RE: *SCOTT'S MILL HYDROELECTRIC PROJECT*
FERC PROJECT NO. 14867-001
RESPONSES TO COMMISSION LETTER OF OCTOBER 28, 2020

On October 28, 2020, the Federal Energy Regulatory Commission (Commission) transmitted a deficiency letter to Scott's Mill Hydro, LLC (FERC No. P-14867-001). On November 20, 2020 Scott's Mill filed an initial response to the Commission notifying the Commission that Scott's Mill intended to move forward with the exemption application. The November 2020 letter also stated that Scott's Mill was working with the U.S. Fish and Wildlife Service (USFWS) and Virginia Department of Wildlife Resources (VDWR) to convert the Agreement in Principle (AIP) to a Settlement Agreement (SA). Further, Scott's Mill informed the Commission that it was working with Liberty University (LU) to enter into a long-term lease for a parcel on the headpond in Amherst County in order to install a public boat ramp.

General Project Location Map

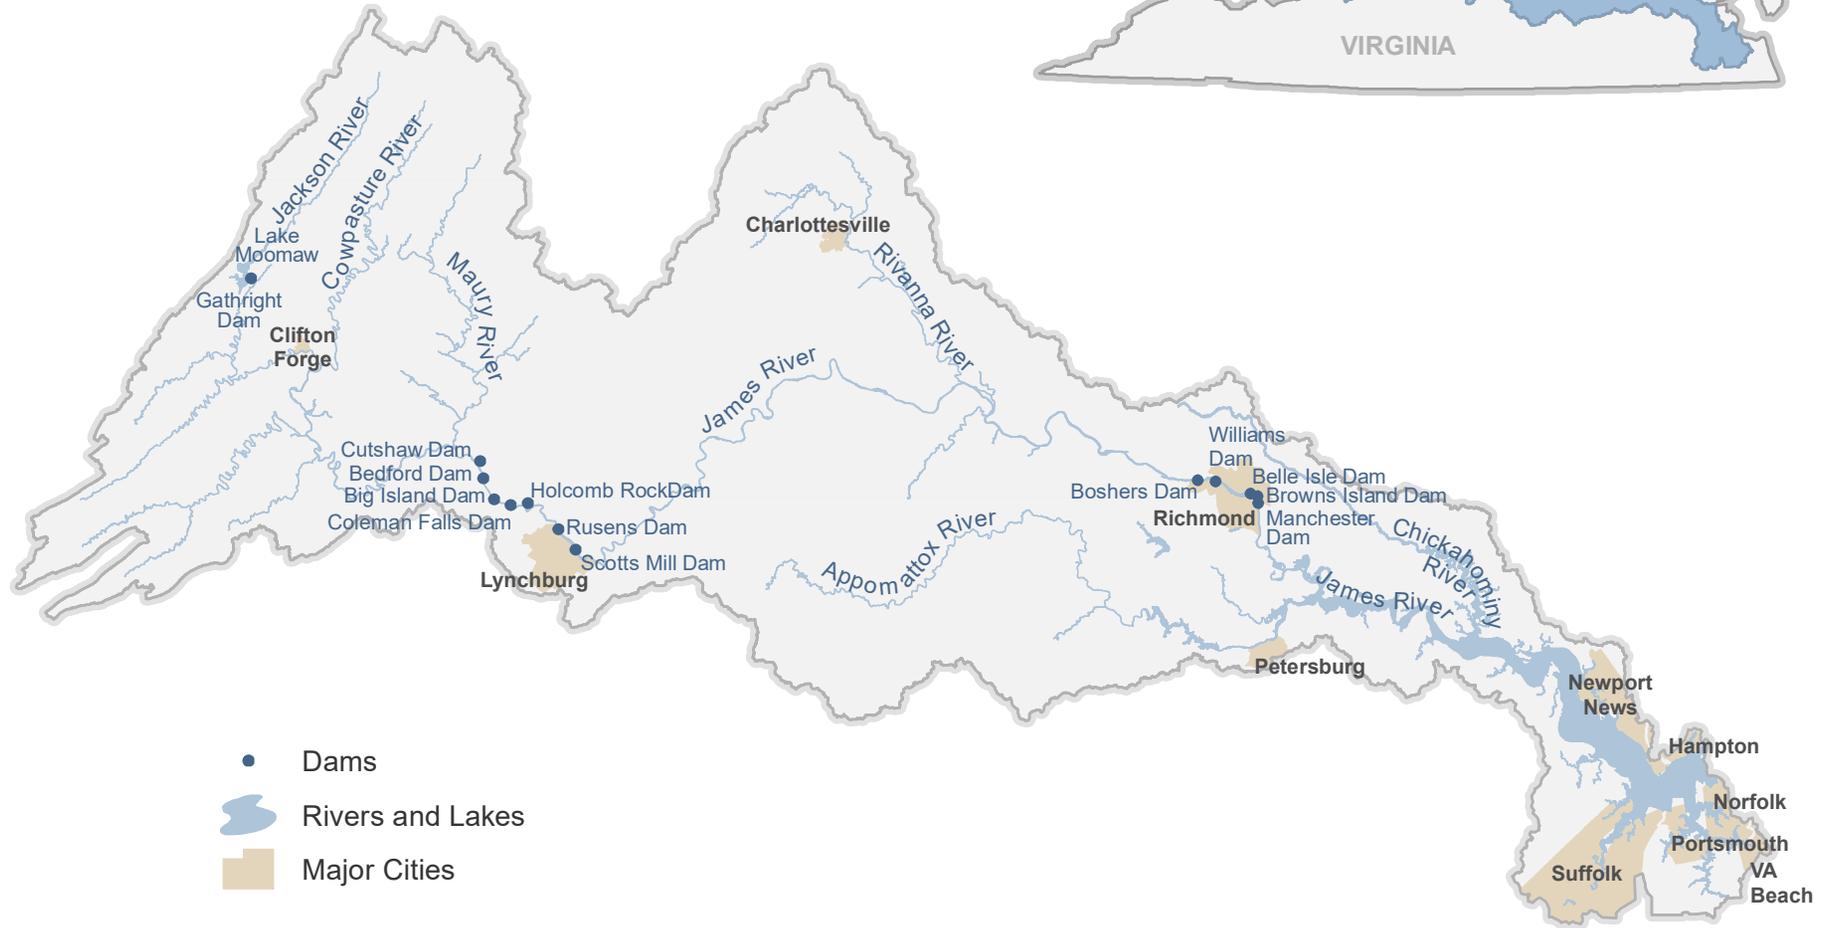
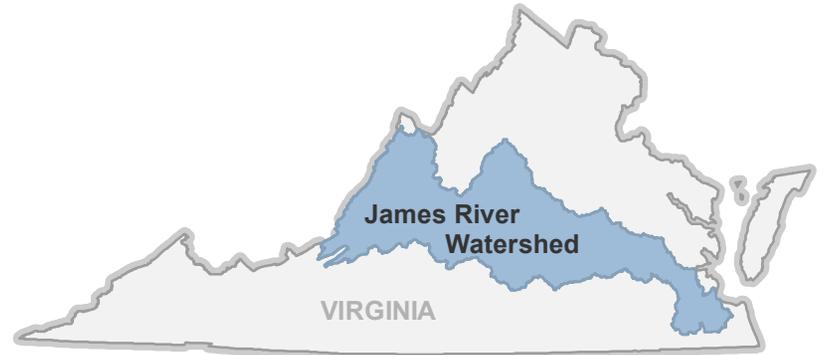
9. The project location map (figure A-1) in Exhibit A is difficult to read and interpret. Please modify the map by providing an inset (watershed) map that is separate from and does not blend into the main map; also include a scale bar on the main map.

Figure A-1 has been modified to add a bar scale and clearly separate the inset from the location map.
